Docket Nos. 50-259, 50-260,  
50-296 and 50-263

MEMORANDUM FOR: Thomas A. Ippolito, Chief, Operating Reactors Branch #3,  
DOR

SUBJECT: SWELLING IN G.E. HIGH-DENSITY SPENT FUEL STORAGE RACKS

FIGURE 2  
STORAGE CELL DIMENSIONS

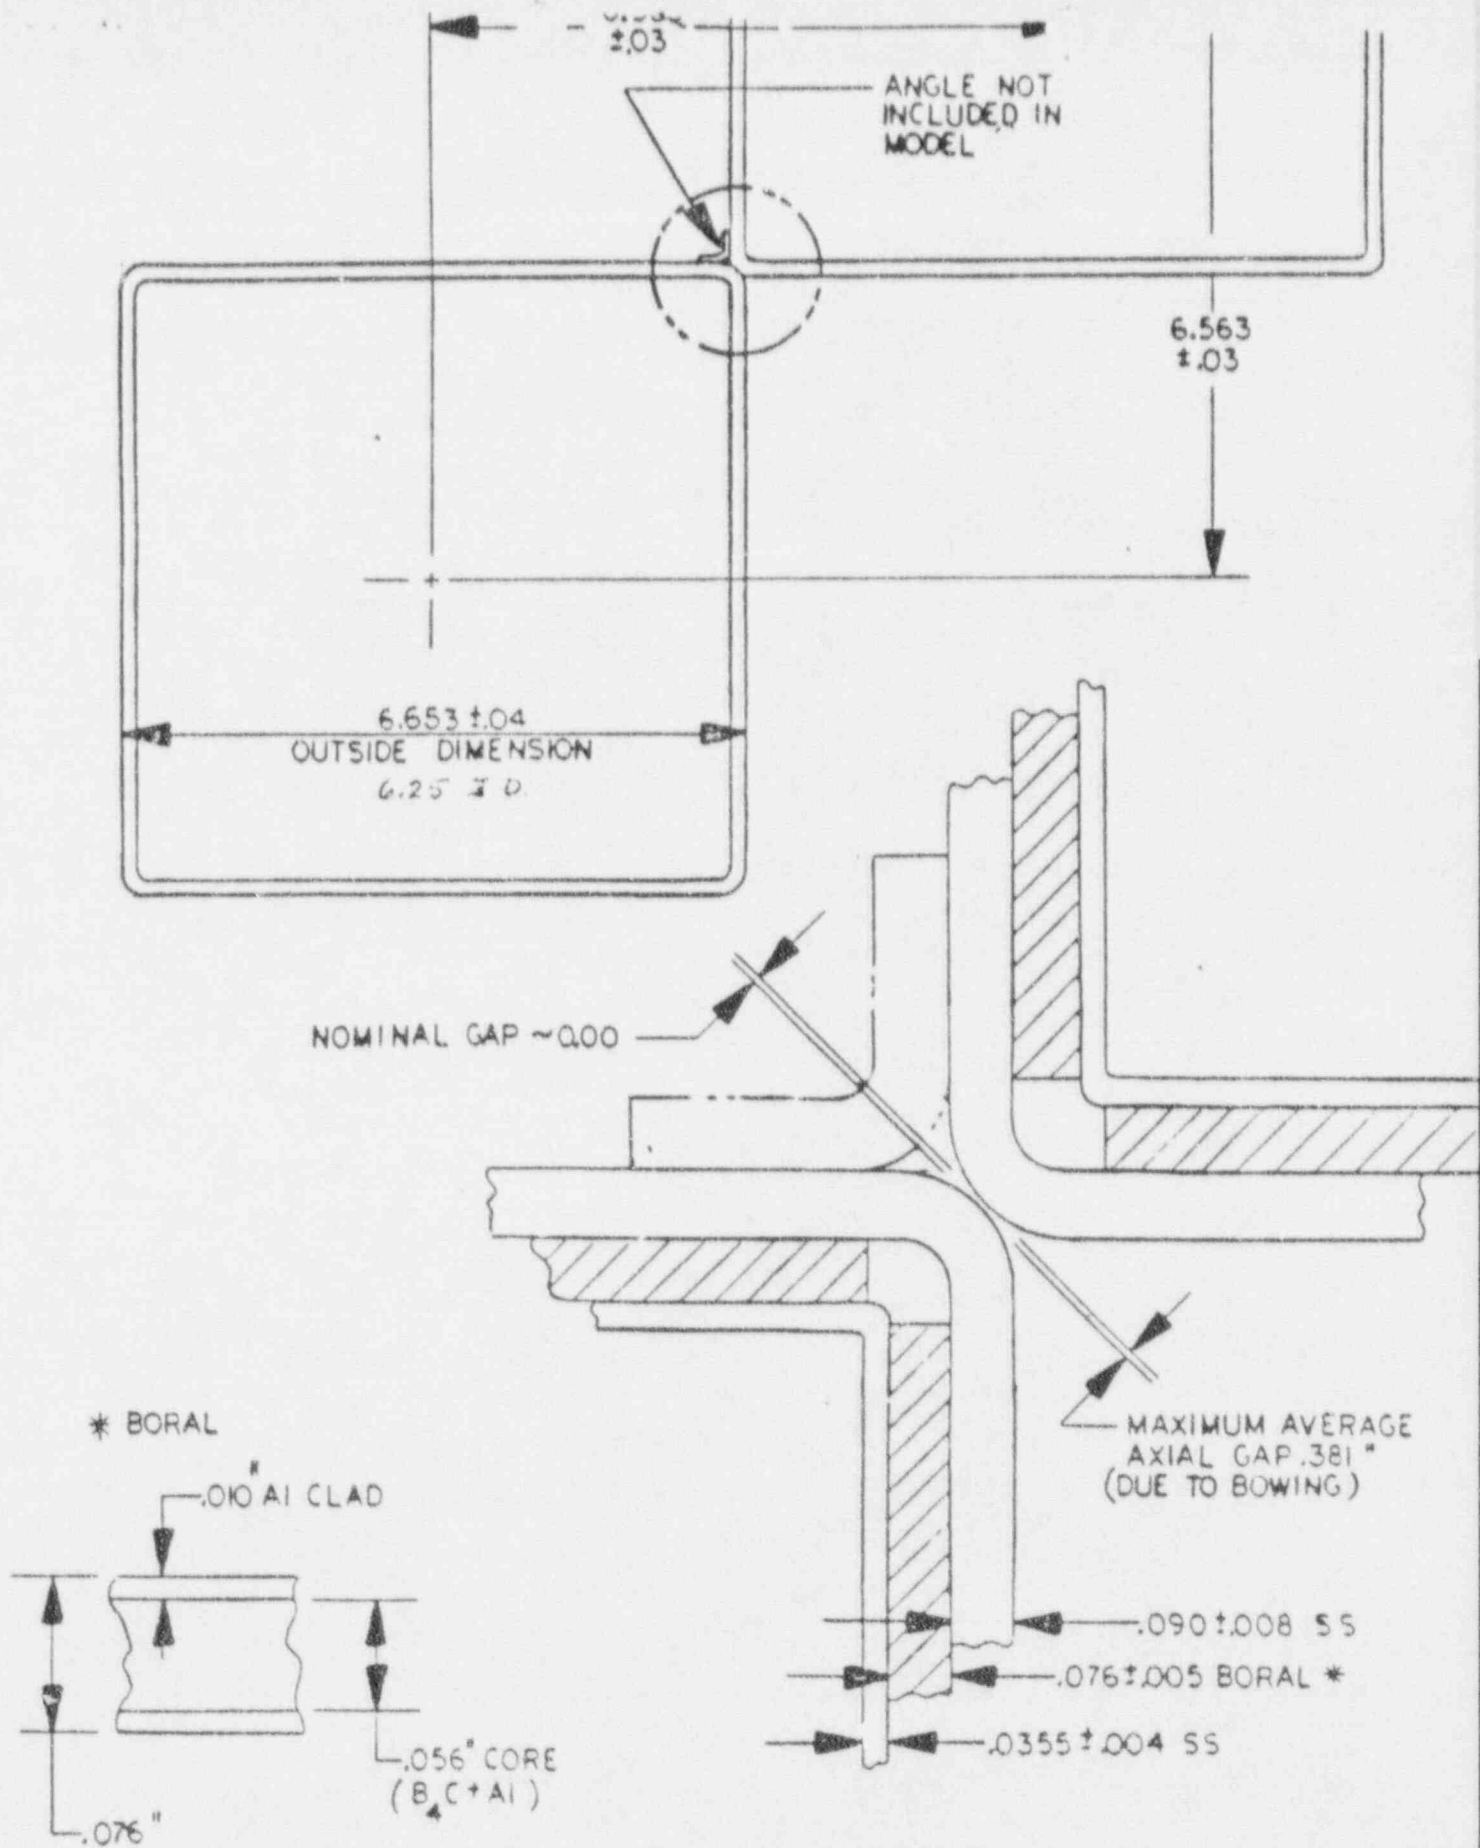
After the tubes were fabricated and inspected at Brooks and Perkins, the tubes were fabricated into racks (modules) at Memphis, Tennessee by CBIN/GE. As shown in Figure 2, an angle is welded onto the sheet metal tubes to join them together. When the initial racks were being fabricated by CBIN, there were instances of burn-through during welding of the angles.

The sandwich construction of the tubes was intended to be leak-tight. It appears that the leaks in the tubes at Monticello (evidenced by the bubbling and swelling) was most likely the result of (1) failure to seal the tubes during fabrication at Brooks and Perkins, (2) the welding performed on the tubes during fabrication of the racks at Memphis and/or (3) on stresses induced on the angle welds during transport and handling of the racks.
